**MEMORANDUM**

SUBJECT: Preliminary OP Report for Z.C. 06- 14 B, Modification Request for Washington Gateway PUD
Square 3584, Lots 23, 811 – 813, at Florida and New York Avenues

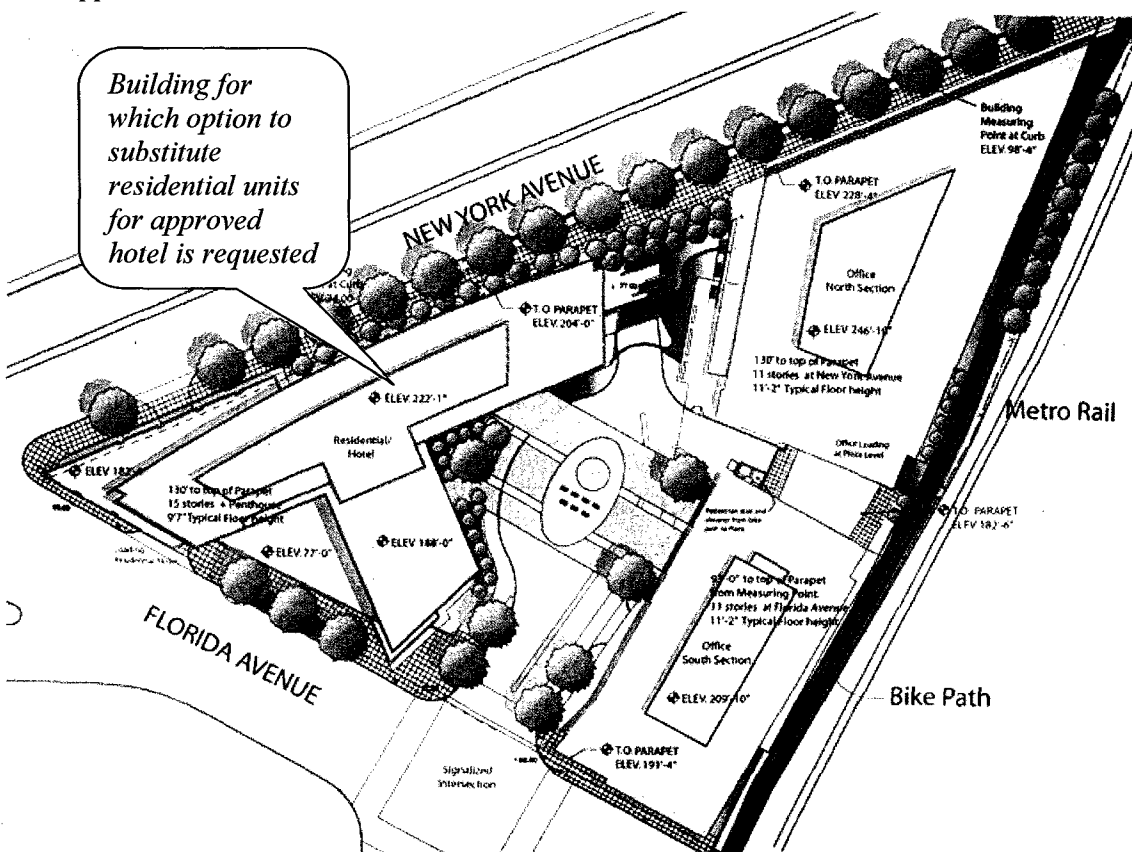
The PUD is on a triangular 3.1 acre site bounded by New York and Florida Avenues and the Metropolitan Branch (bicycle) Trail (MBT) adjacent to the right of way of Metrorail's Red Line, as shown on the approved site plan to the left. It is approved to consist of:
